Technical product information

Topic	V8T-Oil leak between engine and gearbox
Market area	Bentley: worldwide (2WBE),Hongkong-Macau (5HK)
Brand	Bentley
Transaction No.	2042494/2
Level	EH
Status	Approval
Release date

New Continental and Flying Spur equipped with V8T engine

Figure 1

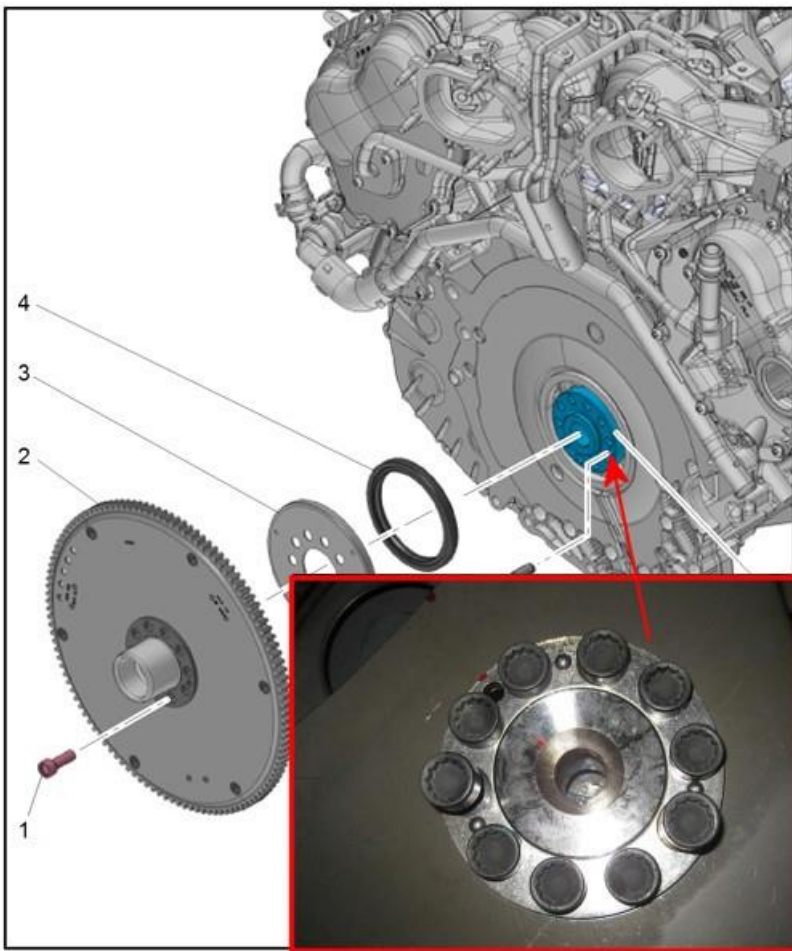
Oil is evident at interface between the engine and gearbox (see Figure 1)

Identify precisely the source of the oil leak. If necessary photograph the area then, clean the engine and reassess the vehicle after a test drive (see Figure 1)
